From: Norman Hopkins [norman@amyhrf.org]
Sent: Wednesday, January 25, 2012 10:10 AM
To: Docket, Hearing; Flyntz, Matthew
Subject: Federal Register 77561, Contention 4A
Attachments: Florida Register77561.pdf

Limited Appearance Statements Related to Contention 4A - Federal Register 77561

Kings Bay Saltiness⁽³⁸⁾

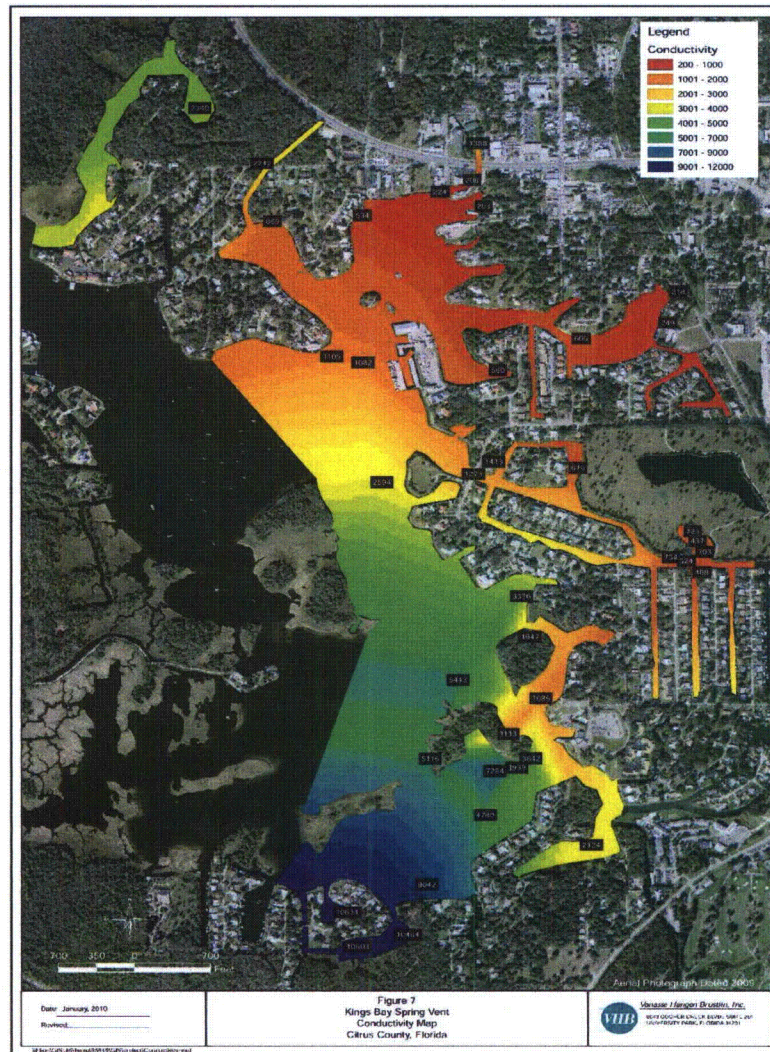
Moreover, studies⁽³⁸⁾ show that increases in saltness from some spring discharges are already happening as the result of up-welling as depicted as Kings Bay Saltness on the next page following.

The darker blue in the SW indicates higher (saltier) conductance with the lower readings shown brown to the north. Conductance measurements recorded from the spring vent discharges, vary with seasonal rainfall amounts. The increased saltiness from the springs appears not to be due to intrusion of sea water from the Gulf in the river.

The principal underground tributary flows of the aquifer contribute to the phenomenon⁽⁸⁾. The Aquifer tributary flow trending SE to NW serving spring vents in the south of Kings Bay experiences excessive pumping from a large housing complex on its path. The Aquifer tributary flow trending NE to SW serving spring vents in the north and east sectors of Kings Bay appears to by-pass any such pumping and have significantly lower levels of saltiness.
